RE: Lower Kickemuit Reservoir Dam Removal – Shellfish Survey Plan

Re: **Technical Review Comment Responses**
WQC File No. 21-148; Upper and Lower Kickemuit Dam Removals
(Pare Proposal No. 14217.07)

Re: **Technical Review Comment Responses**
RIDEM Freshwater Wetlands Application No. 21-0229
(Pare Project No. 14217.05)

Attachments: Figure 1 Shellfish Survey Plan

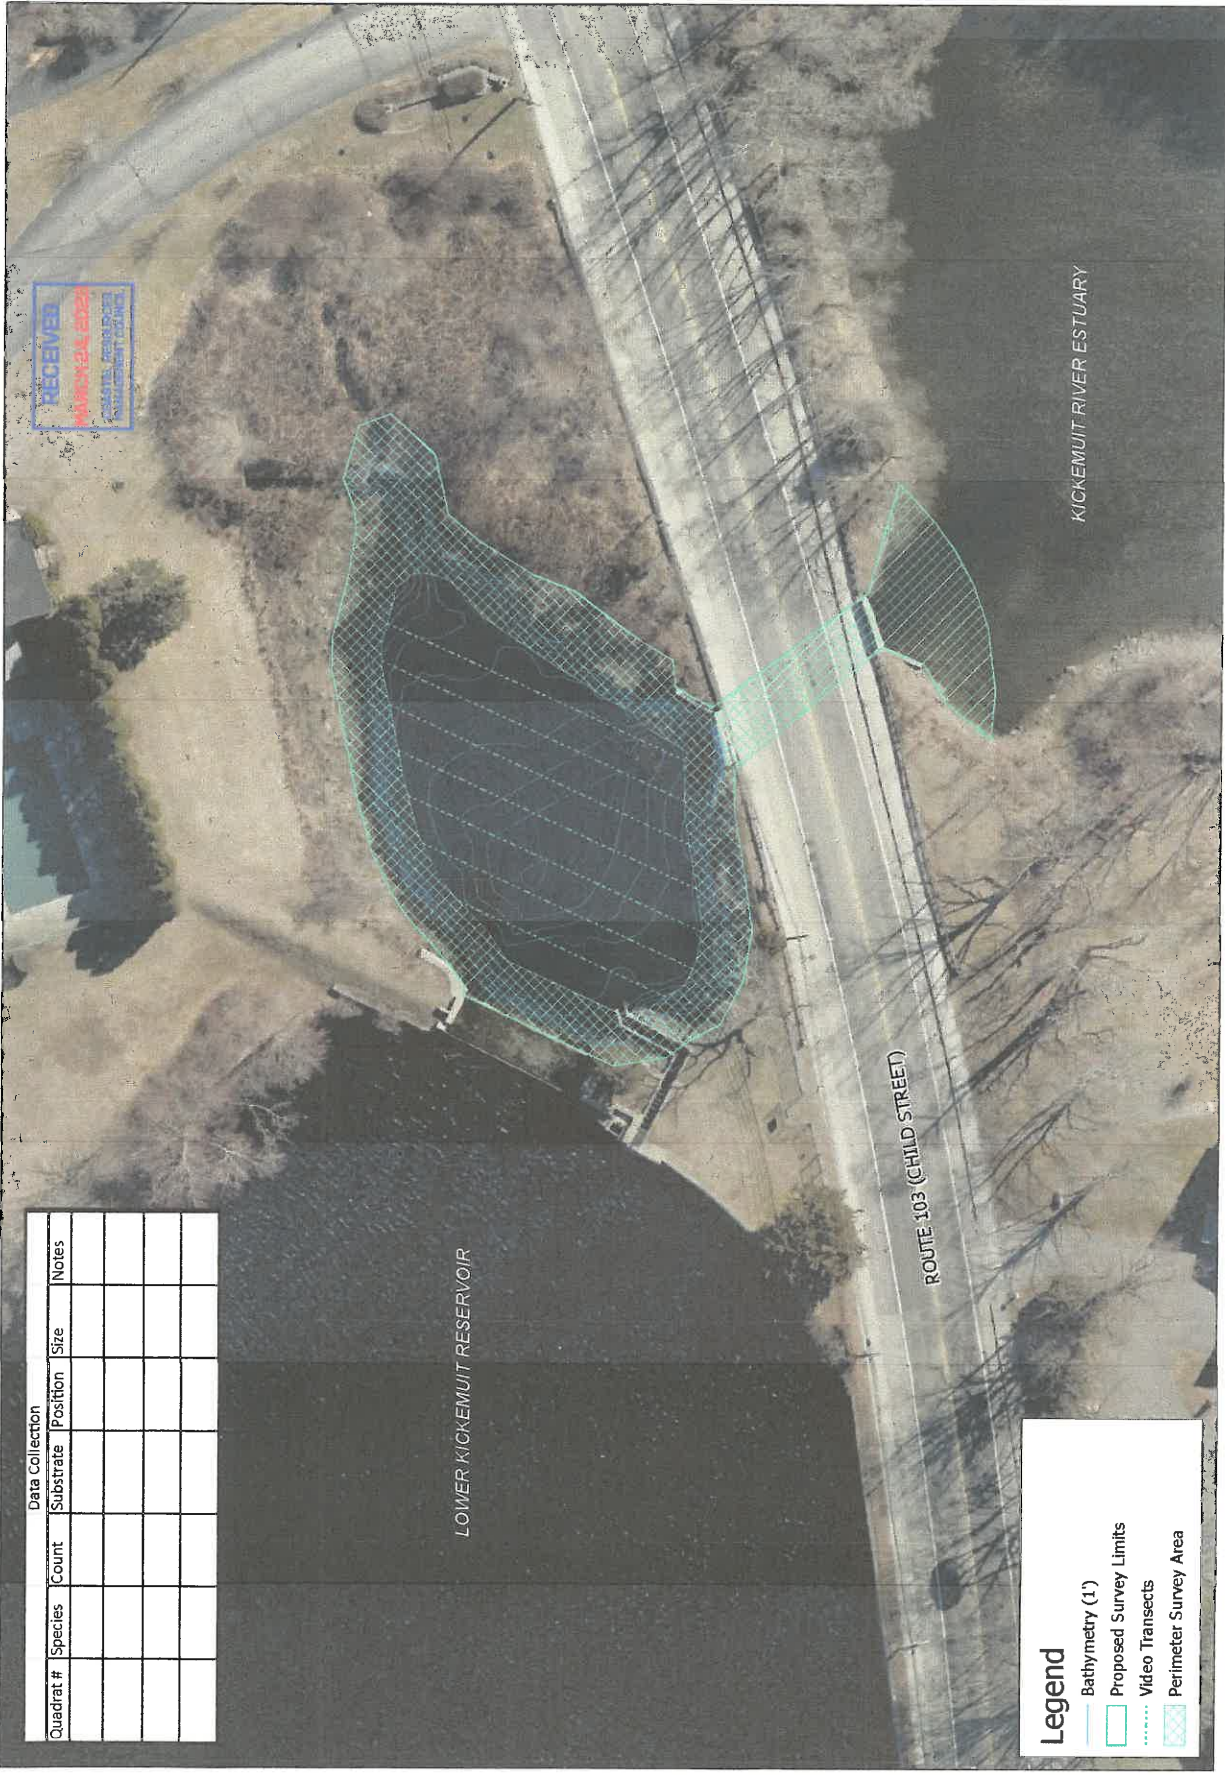
11. Page 4 of the EFH Assessment Worksheet, included in Section 8 of the Application for State Assent, states that there will not be impacts to shellfish beds or oyster reefs from this work. Recent survey work conducted by DMF has documented natural oyster populations within the project footprint and directly downstream of the footprint that will be directly impacted by the proposed work. To minimize direct impacts and loss of natural oyster populations located directly below the lower impoundment and Child Street, and below Child Street, a mitigation and relocation plan must be designed, in consultation with DMF, that at minimum includes additional shellfish surveys to locate oysters, relocating oysters during project construction, and then translocating them to suitable habitat after construction completion. In addition, substrate enhancement may be required to compensate for mortality to standing stocks that will likely occur from the relocation and construction processes. Details of the mitigation and relocation plan will need to be included in your response to this comment.

RESPONSE: Two meetings have been held with RIDEM Department of Marine Fisheries (DMF) to coordinate shellfish survey and temporary relocation plans since the receipt of this comment letter. The attached Shellfish Survey Plan details the proposed shellfish survey limits and methodology based upon coordination with the DMF. Survey results will inform the current oyster abundance and habitat type including location within the water column and preferred structure. Once these variables are known, a temporary relocation plan will be developed so that oysters are re-located to similar habitat that will minimize distress and mortality associated with relocation. The proposed dam removal will result in the restoration of approximately 37.6 acres of sub-tidal and intertidal estuarine habitat that will be available to oyster colonization. It is proposed that this major estuarine restoration provides mitigation for oyster relocation. There is opportunity for oysters relocated from the work area to be transported upstream of the lower dam once construction is complete to enhance oyster establishment in the restored estuary. Additionally, the proposed Restoration and Monitoring Plan will be revised to include recording the presence and abundance of shellfish identified along transects to inform post dam removal responses.
